Technical BULLETIN

SAFETY RECALL

CERTAIN 2021 AND 2022 MODEL MT09M/MC/N/NC (MT-09), MT09SPM/MC/N/NC (MT-09 SP), AND MTT9GTM/MC/N/NC (TRACER 9 GT) MOTORCYCLES FACTORY MODIFICATION CAMPAIGN – Limited Throttle Response / Engine Stall – ECU Reprogramming

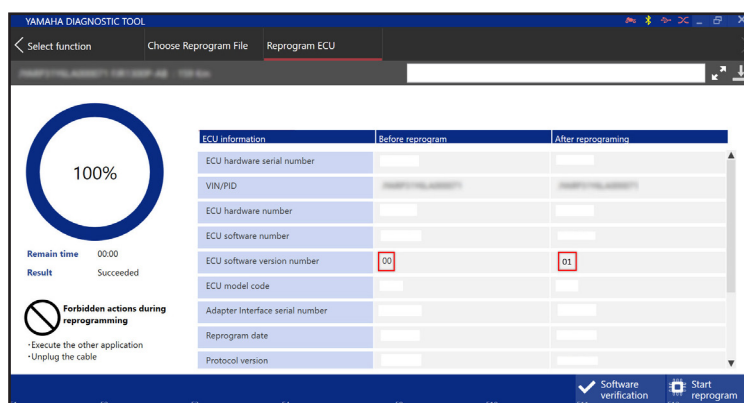
Model	Model Code	ECU Part Number	Software Number	Software Version*	File Name
MT09M	B7N4 B7NF	B7N-8591A-11-00	Before: 121DE040 After: 121DE041	Before: 00 After: 01	202201_B7N4_01.rpf
MT09MC	B7N5 B7NG	B7N-8591A-61-00	Before: 121DE180 After: 121DE181	Before: 00 After: 01	202201_B7N5_01.rpf
MT09SPM	BAM4 BAMB	BAM-8591A-11-00	Before: 1245D040 After: 1245D041	Before: 00 After: 01	202201_BAM4_01.rpf
MT09SPMC	BAM5 BAMC	BAM-8591A-61-00	Before: 1245D180 After: 1245D181	Before: 00 After: 01	202201_BAM5_01.rpf
MTT9GTM	BAP5 BAPD	BAP-8591A-11-00	Before: 12460040 After: 12460041	Before: 00 After: 01	202201_BAP5_01.rpf
MTT9GTMC	BAP6 BAPE	BAP-8591A-61-00	Before: 12460180 After: 12460181	Before: 00 After: 01	202201_BAP6_01.rpf

*After reprogramming, you can confirm the Software Version number as shown below.
